SUBJECT: R. E. GINNA NUCLEAR POWER PLANT – STAFF ASSESSMENT OF
RESPONSE TO 10 CFR 50.54(f) INFORMATION REQUEST – FLOOD-
CAUSING MECHANISM REEVALUATION (CAC NO. MF6098)

STAFF ASSESSMENT BY THE OFFICE OF NUCLEAR REACTOR REGULATION

RELATED TO FLOODING HAZARD REEVALUATION REPORT

R. E. GINNA NUCLEAR POWER PLANT

Figure 3.1-1. Ginna Site Features

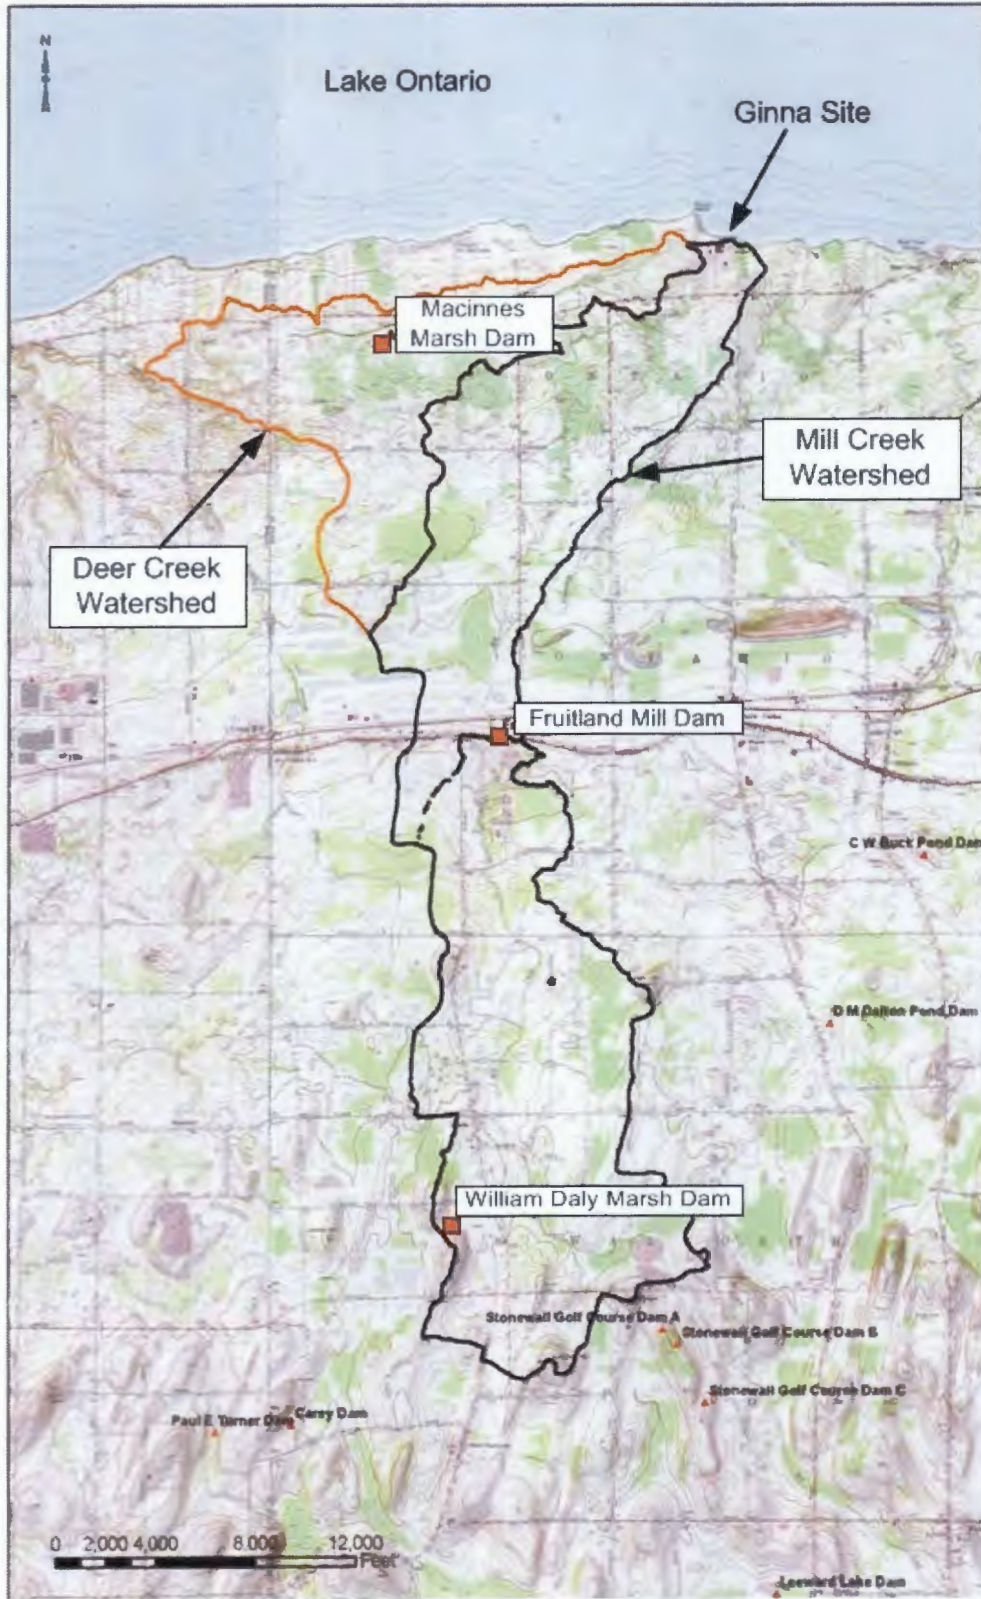
The licensee reported in the Ginna FHRR that the reevaluated flood hazard for LIP results in a stillwater-surface elevation ranging from 255.8 ft (77.97 m) NGVD29 at the turbine building, screen house, and diesel generator building, to 270.9 ft (82.57 m) NGVD29 at the reactor containment and control buildings (Figure 3.1-1) (CENG, 2015). Wind wave and runup effects

The NRC staff verified that FLO-2D simulated values of maximum LIP flood elevations at the Ginna site range from 255.8 ft (77.97 m) near the screen house to 270.9 ft (82.97 m) NGVD29 at the reactor containment and control buildings, and that these values are consistent with those documented in the Ginna FHRR (CENG, 2015) and relevant calculation packages.

The licensee reported in the Ginna FHRR that the reevaluated flood hazard for streams and rivers results in a peak stillwater-surface elevation that range from 258.2 ft (78.70 m) NGVD29 at the turbine building, where wind waves and runup are not applicable, to 258.2 ft (78.70 m) NGVD29 at the screen house, where wave effects are applicable, to 273.5 ft (83.36 m) NGVD29 at the proposed standby feedwater pump building annex, where wind waves and runup results in an elevation of 274.4 ft (83.64 m) NGVD29. A summary table of peak WSEs for all controlling scenarios, which are described in the section below, is provided in Table 3.3-1. Bold values in this table represent values provided in the ISR letter (NRC, 2015b). Building locations are shown in Figure 3.1-1.
